FCC APPLICATION INQUIRY RESPONSE
L82-228869: SIEMENS GIGASET 2400 HANDSET

Correspondence Number: 3654

September 25, 1998

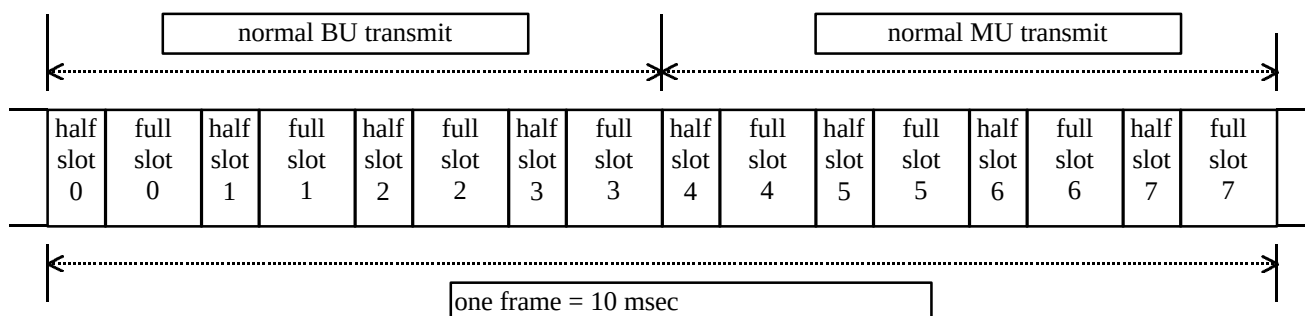
- (1) **The bandwidth plot for channel 95 of this transmitter does not appear to be centered on the operating frequency specified for channel 95 in the test report. The operating frequency for channel 95 shown on page 16 is 2483.136 MHz. This bandwidth plot is centered on 2482.83 MHz, a difference of 306 kHz. This may not seem like much, but if I assume that the center frequency of the submitted channel 95 bandwidth plot is 2583.136 MHz, the 2483.5 MHz bandedge is only 2.5 divisions above the center of the plot. At this point, transmitter emission on channel 95 is NOT 20 dB down from the peak. It is approximately 17 dB down. Also, if the peak radiated field strength of the fundamental emission on channel 95 is 124.2 dBuV/m, the peak field strength of the emission peak located at the restricted band frequency of 2483.5 MHz is 107.2 dBuV/m ($126.2 - 17 \text{ dB} = 109.2$). This is 33.2 dB above the peak limit of 74 dBuV/m. Please address this issue of possible non-compliance.**

The original version of Part 15 (Oct 1996) version that we were using showed the limit for this section (15.247(c)) shall be either 20 dB down or meet 15.209, whichever has the least attenuation. The revised (July 1998) version of this document states the 20 dB criteria without a 'least attenuation' criteria. The appropriate portions of 15.205 must also be met.

Following the last inquiry made by Joe Dichoso, a recheck of the center frequencies for the Desk Station and Handsets were made. Revised occupied bandwidth data was taken with full calibration and tuning of the analyzer verified as well as the integrity of the shield cover for the EUT verified (this was found to be a factor in the center frequency for the devices). The emission center frequency is now very close to the nominal figure and all bandedges are now within the 20 dB criteria. The occupied bandwidth still meets the requirements of the Rules. All of these tests were made with the EUT in fixed frequency mode.

Measurements of the emissions of the EUT in fixed frequency mode set to Channel 95 were made at the base of this restricted band. Measurements were made using average detection criteria in accordance with Section 15.205 (b) of the Rules (measurement above 1 GHz). All emissions in this area were below the 15.205/15.209 limit. Data indicating compliance with the 15.205 restricted band is included with this submission.

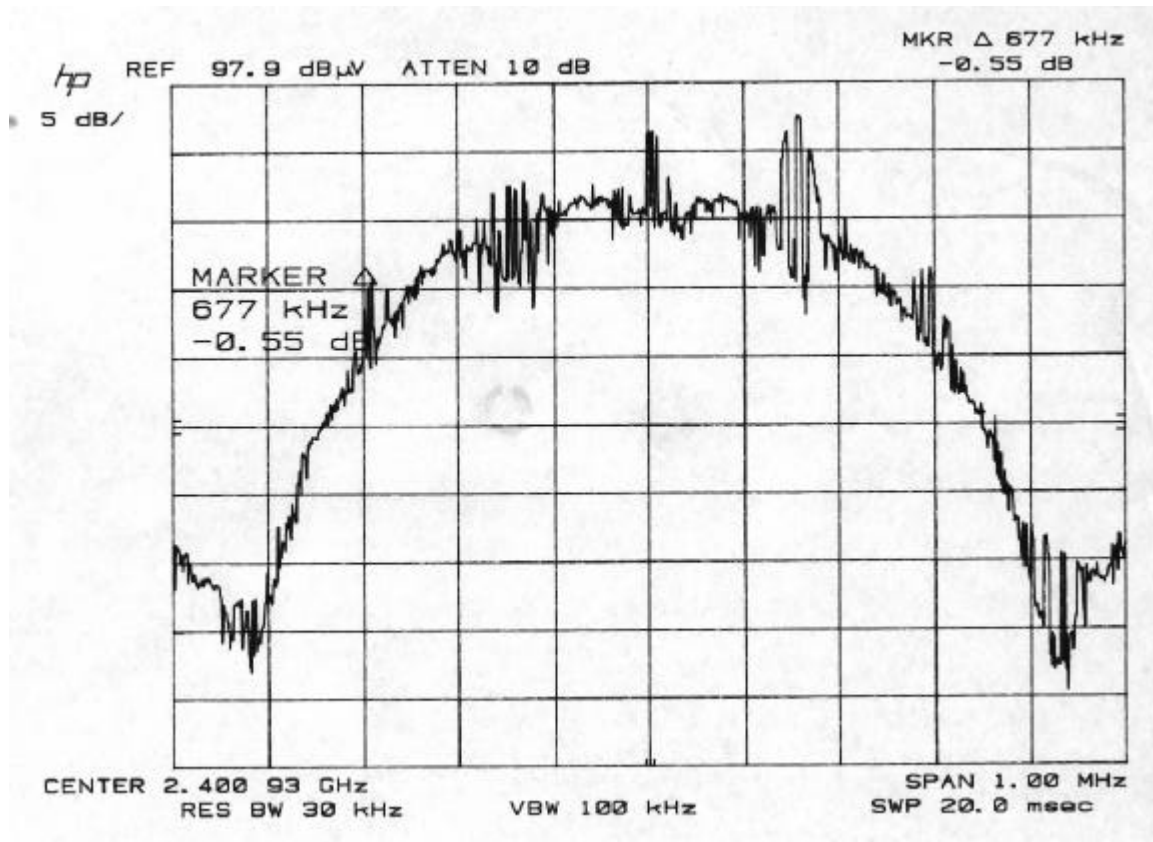
- (2) **Provide information that verifies that the worst case duty cycle for this transmitter is 1/8 based upon RF on versus RF off time. No such information can be found in the filing.**

Following this morning's request, a more detailed explanation of the timing for the transmit cycle of the Siemens SOHO System was performed. The net duty cycle for the system is actually lower for the handset than previously provided. The analysis of the duty cycle for this system is derived from the timing diagram for the transmit cycle of the Siemens SOHO System shown below:

The half time slots are used for processor activities inside the system components and no transmissions (from either component) occur during these periods. Each full slot is equal to two half slots, which divides the total time for the period into 24 segments (half slot lengths).

The base unit can transmit during all base unit labelled full time slots (in the normal BU bracket), but the an individual handset can only transmit during one full time slot (two segments wide) in the normal MU (Mobile Unit) bracket. This is due to the presence of only one base unit but multiple handsets per system configuration.

Handset Duty Cycle = $2/24 = 1/12$
